Three Mile Island Unit I (TMI Unit 1)
Operating License No. DPR-50
Docket No. 50-289

Subject: Additional Information Regarding Kinetic Expansion Inspection and Repair Criteria

**Inspection Acceptance Criteria
And
Leakage Assessment Methodology
For TMI
OTSG Kinetic Expansion Examinations**

RESPONSES TO PRIOR NRC ISSUES/QUESTIONS

FIGURE 1

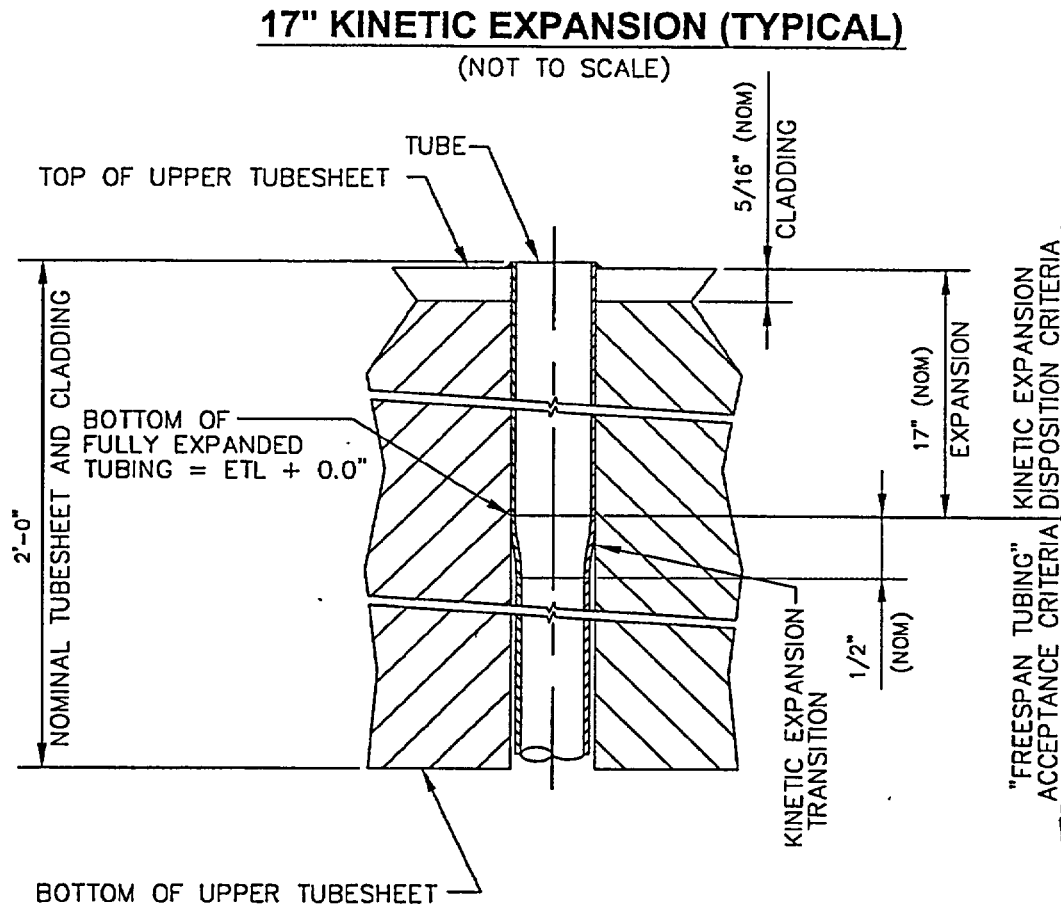
Question 6

As described in the response to question 5, above, the finite element analysis that was used to evaluate the flaw tolerance of the kinetic expansions was a 6" long model (consisting of 5.5" of fully expanded tubing and a 0.5" transition.)

It should be noted that the above discussion pertains to the evaluation of the kinetic expansions (i.e., fully expanded tubing). During the examinations the kinetic expansion transitions are also examined with the MRPC probes, evaluated for the presence of flaw indications, evaluated as freespan tubing, and repaired if required.

Figure 1, which follows, provides an illustration of a typical kinetic expansion.

FIGURE 2
"Defect Free" Concept

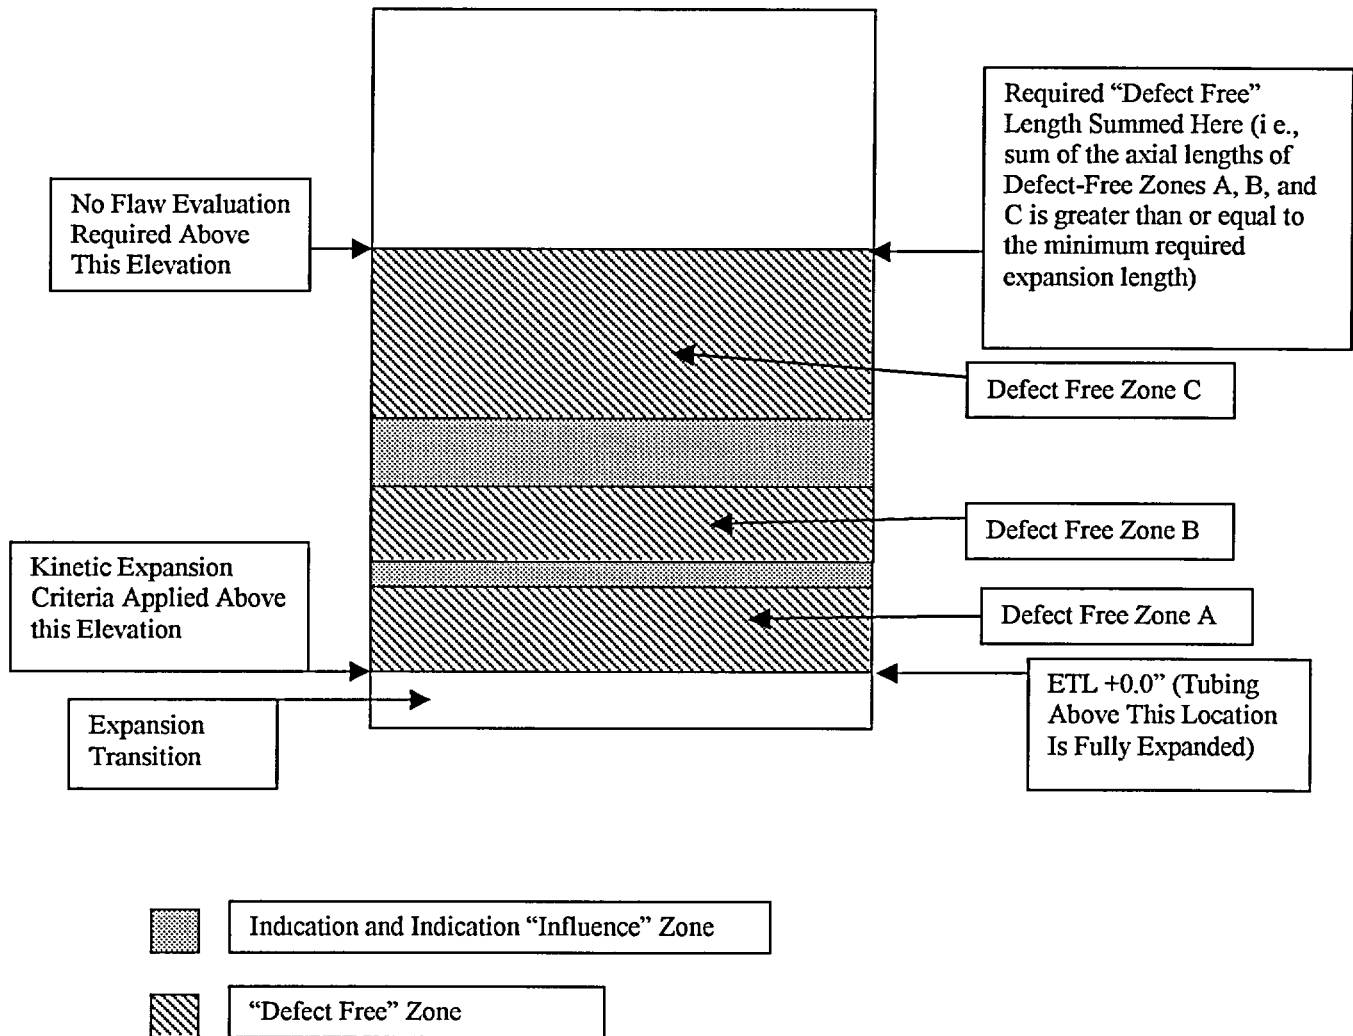
Reference 1 states, *"In the context of the preceding issues, the licensee needs to specify what actions would be taken if insufficient defect-free tubing is identified in the full qualification length. For example, would the inspection for sufficient defect-free tubing be allowed to continue higher in the tubesheet? The NRC staff requests that the licensee provide the technical basis for continued inspection or for other actions that would be taken."*

TMI-1 does not use the phrase "full qualification length" in its kinetic expansion acceptance criteria. As described in the above responses, kinetic expansion evaluations are performed beginning at the ETL + 0.00" location to verify that sufficient defect-free lengths are present.

While these TMI-1 structural dispositioning criteria (described in MPR 1820, Rev. 1) are very conservative, there is no requirement that the defect-free joint length be "continuous". The kinetic expansions are flaw tolerant. (For example, burst is precluded due to the presence of the tubesheet; residual compressive stresses are present, bending stresses and vibration are limited; secondary side loose parts are prevented from impacting the tubing) Small defects do not influence the reliability of the kinetically expanded joints. For example, a small volumetric ID IGA pit on the surface of a kinetic expansion will not impact the ability of defect-free tubing, located above or below that pit, to maintain the structural requirements of the joint (e.g., no tube parting, no joint pullout). Outside of the flaw influence zones a small ID-initiated axial crack present along the length of a kinetic expansion would not adversely affect the structural integrity of defect-free tubing located above or below that crack. From a structural standpoint, so long as no flaw or combination of flaws is present with a circumferential extent greater than 0.64", the defect-free tubing located above or below the flaw is an integral part of the kinetic expansion joint. (If the 0.64" circumferential extent value is exceeded prior to the required defect-free length being observed, the kinetic expansion is repaired, since the tube, conservatively assuming 100% throughwall degradation, could theoretically be parted under calculated accident-induced loads.) The expansion evaluations only "move higher into the tubesheet" if the examination data is available, and the repair criteria are not exceeded. The technical basis for this continued inspection (i.e., higher in the tubesheet) is provided in MPR 1820, Rev. 1.
